THE PORT AUTHORITY OF NEW YORK & NEW JERSEY

To: Mr. L. Menno, Manager, Contract Tenant Services Division, WT&EDD
From: Ennala Ramabhushanam
Date: November 22, 1991
Subject: **WTC - ALTERATION APPLICATION W-4636 - CEDEL, S.A. - 1 WTC - 90TH FLOOR - GENERAL CONSTRUCTION**

Reference: Review Request dated 11/13/91

DRAWING NO.: CSK-01

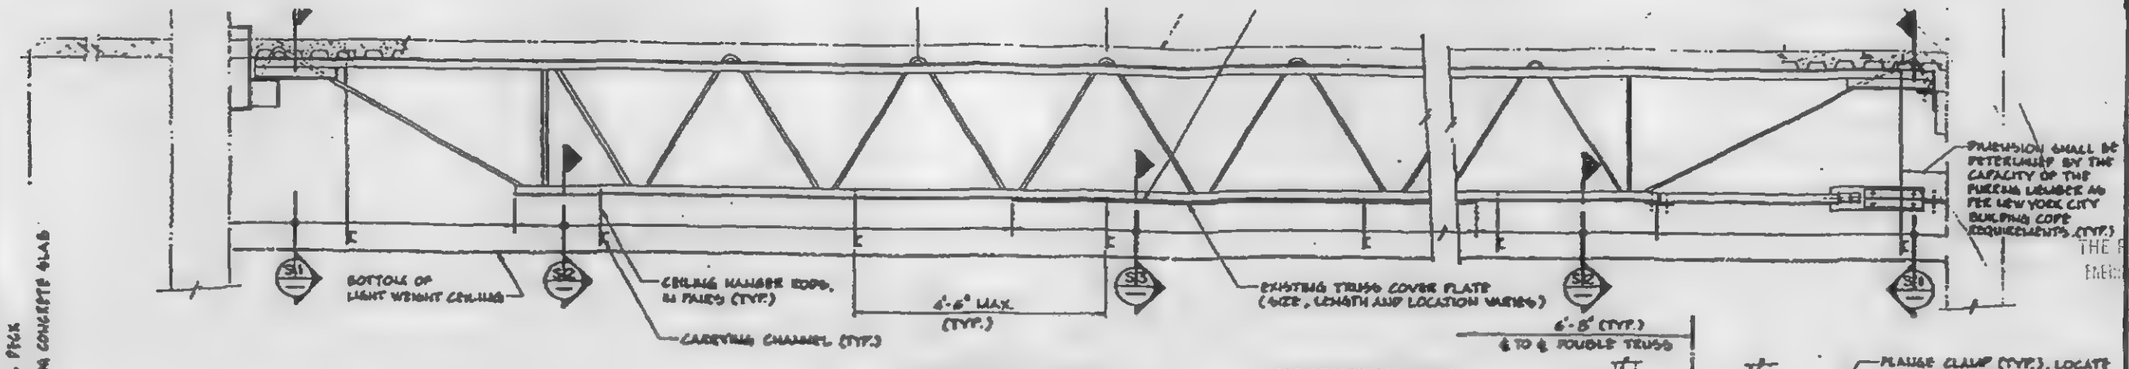
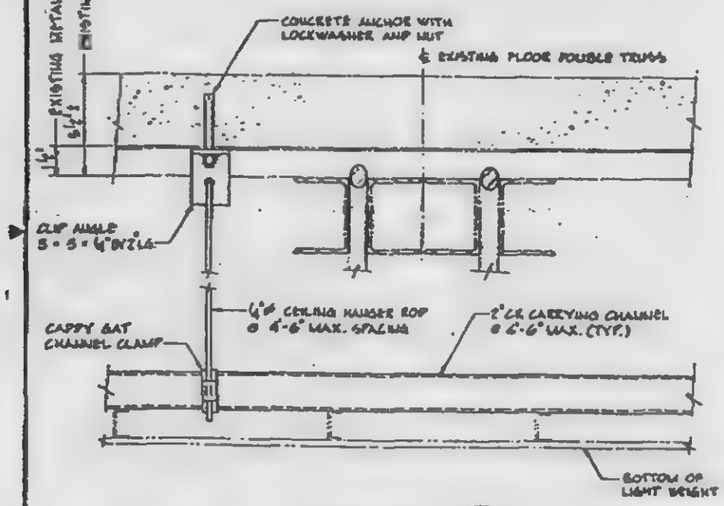
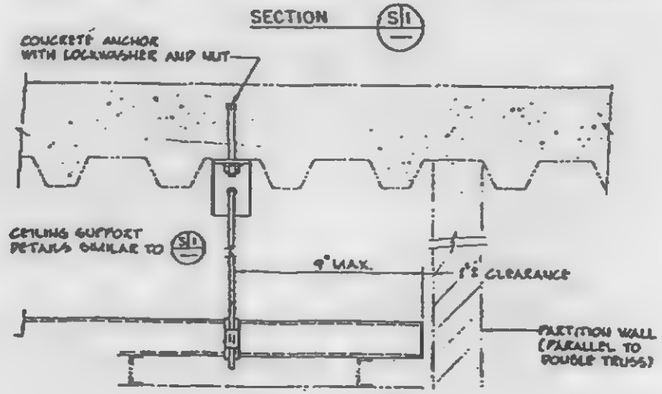
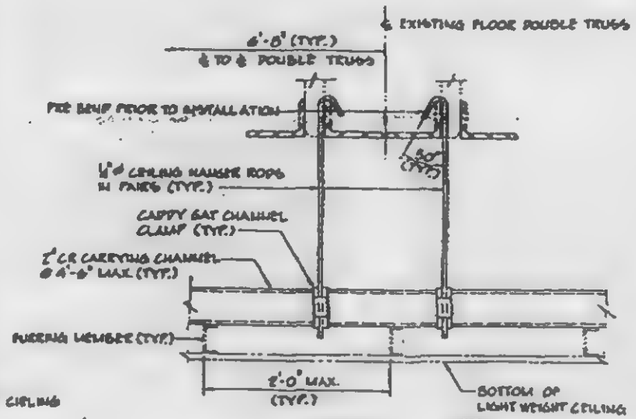
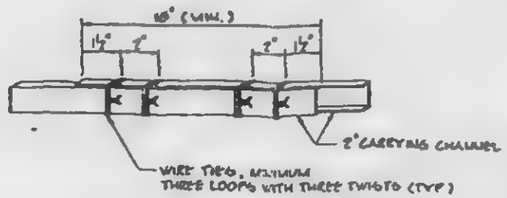
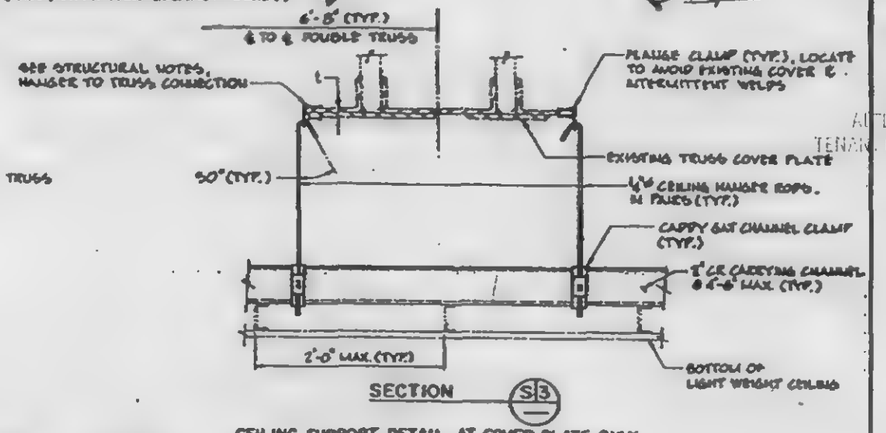
Dwg. A-9, Section 6. For metal studs supporting the suspended "ceiling fixture", please indicate the connection details to the existing construction and submit for review. Please note that PA Standard Dwg. S-1 does not include such a detail as stated in your response. (Modified repeat comment)

4. Dwg. A-9, Section 6. For metal studs supporting the suspended "ceiling fixture," please indicate the connection details to the existing construction and submit for review. (Repeat Comment)

3. Please refer to dePolo/Dunbar drawing A-9 section #6 revised dated September 9, 1991 which clarifies the method of support for this detail.

1. Items 3 & 4 are responded to on the enclosed d/D drawing dated 7.18.91.

DRAWING TITLE: STRUCTURAL CLG SUPPORT DETAILS

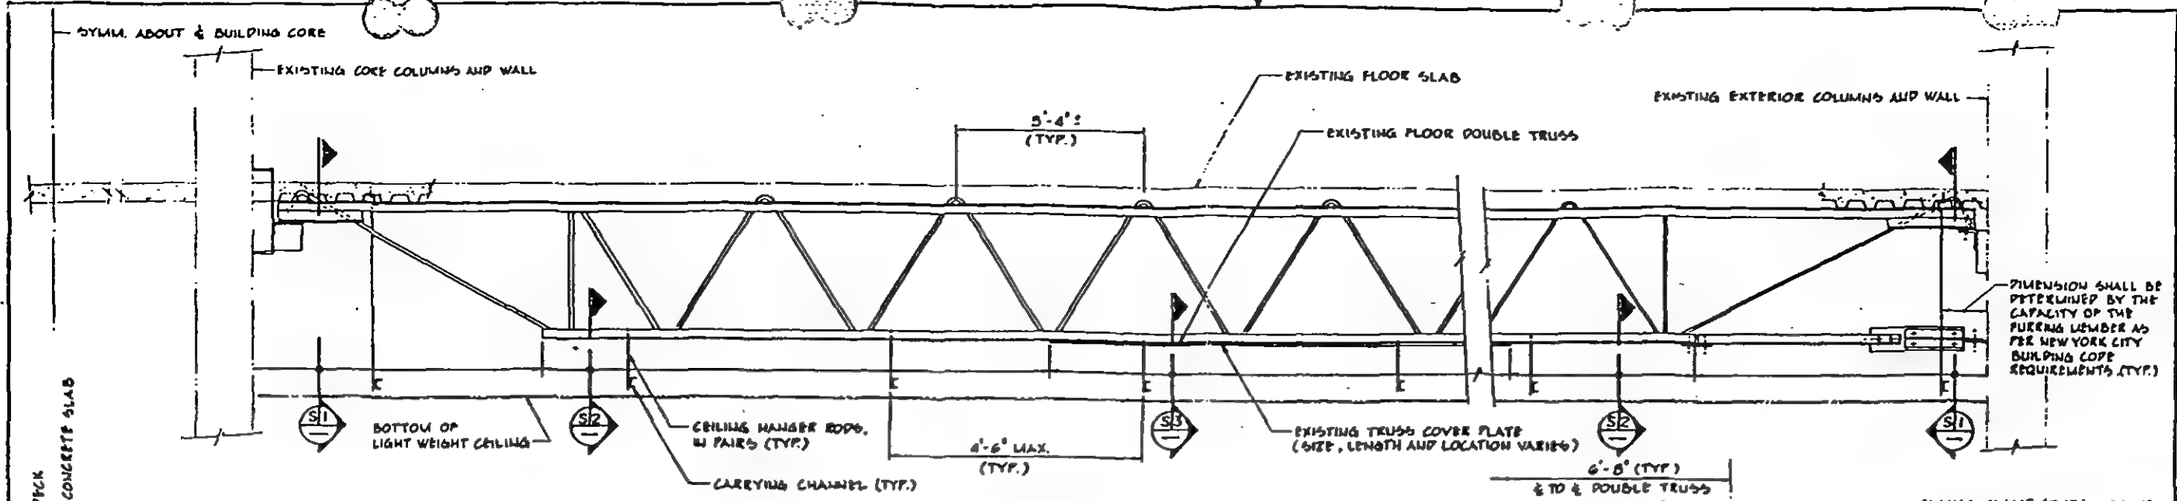
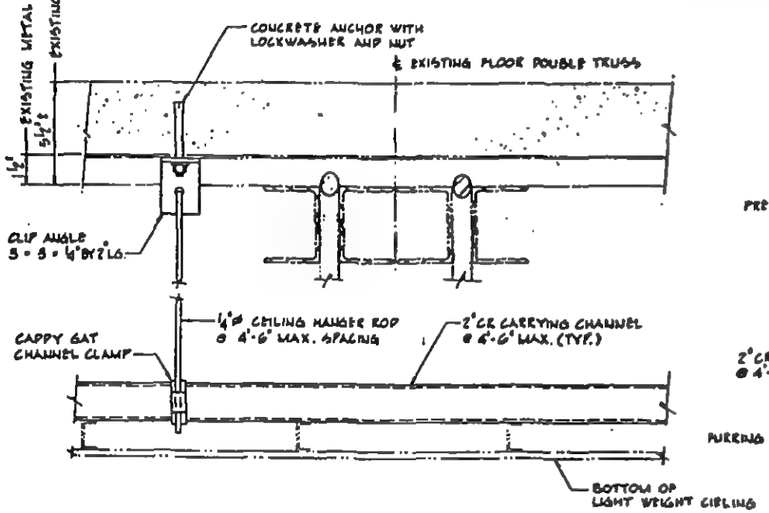
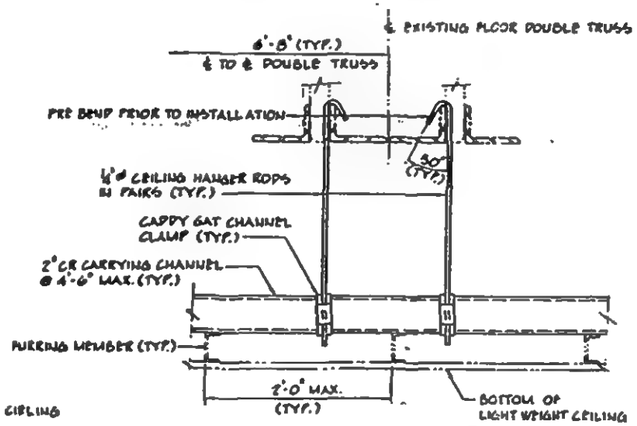
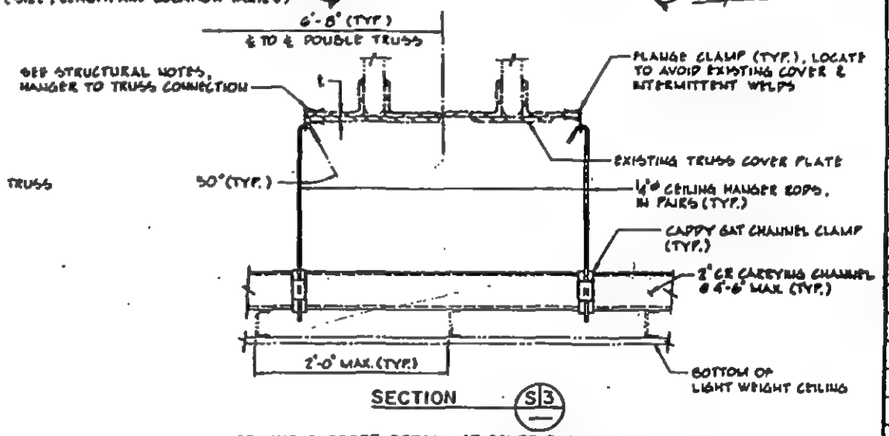
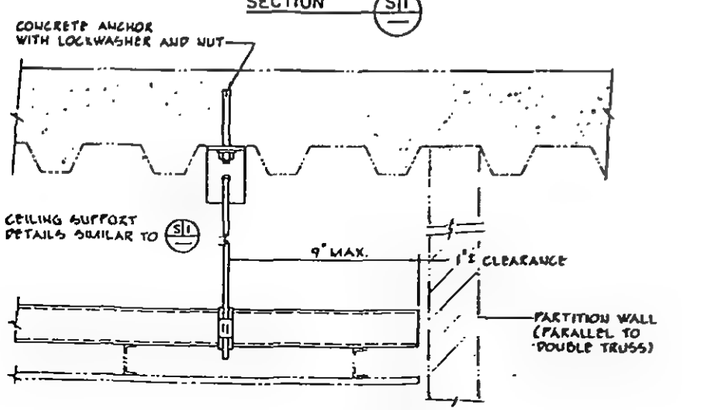
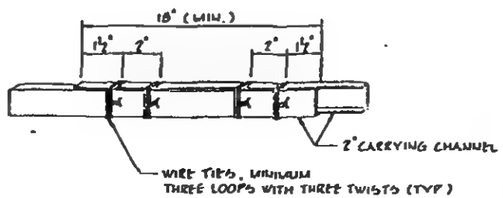
2. Response to comment 3 regarding ceiling suspension details is noted. Please note that the drawing submitted must be included in the contract drawings and should carry, the seal and signature of the engineer ~~if~~ or architect of record, in accordance with N.Y.C. Building Code C27-157.

3. Dwg. A-3, "Typ. Lay-in Acoustical Tile Ceiling," Dwg. A-8, Section D. The ceiling support system shall agree with PANYNJ Dwg. S-1, "Lightweight Ceiling Support System, 1 WTC and 2 WTC." Please revise and submit for review. (Modified Repeat Comment) See Attachment.

No.	Date	Revision	Approved
1	7-15-97	ADDED NOTE No 5	03
